**Regulatory Review of GEH Topical Report  
“BWRX-300 Containment Evaluation Method”  
NEDC-33922P, Revision 2**

**NRC Staff Presentation**

**BWRX-300 Small Modular Reactor  
ACRS Full Committee Meeting**

**April 6, 2022**

# BWRX-300 GOTHIC Containment Response Methodology

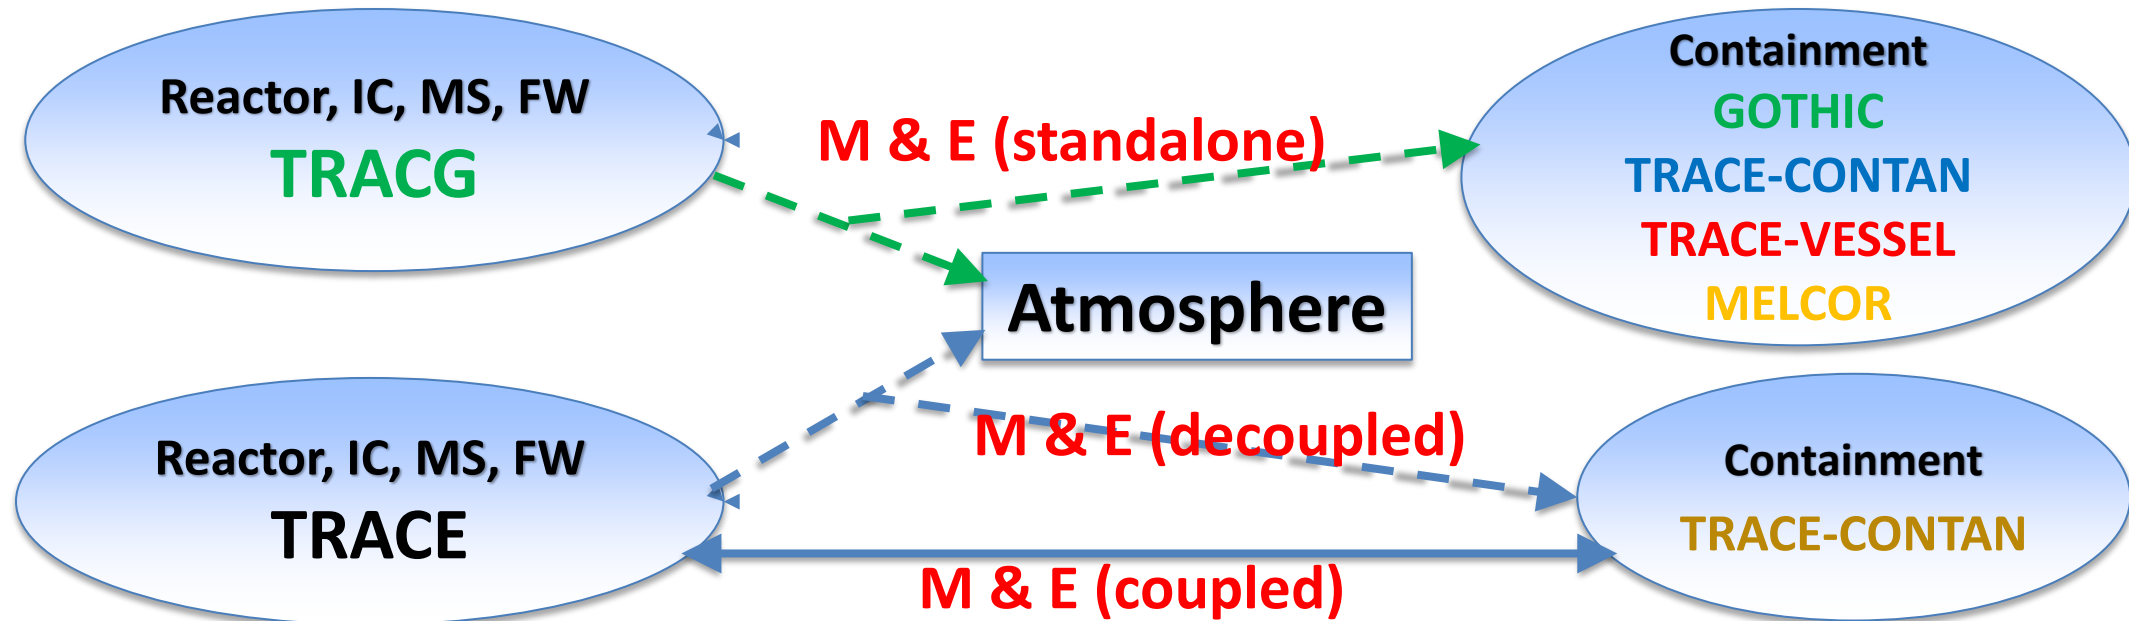
- Physical phenomena (GOTHIC PIRT)
- GOTHIC input model (Nominal inputs, assumptions, and correlations)
- Key modeling uncertainties and conservative biases -- Overall GOTHIC model conservatism
- Nodalization sensitivity studies for the containment and PCCS
- GOTHIC benchmarking of the test data
- BWRX-300 containment sensitivity analyses for large/small breaks
- PCCS capacity to mitigate the containment pressure in the long-term
- Containment mixing for combustible gases
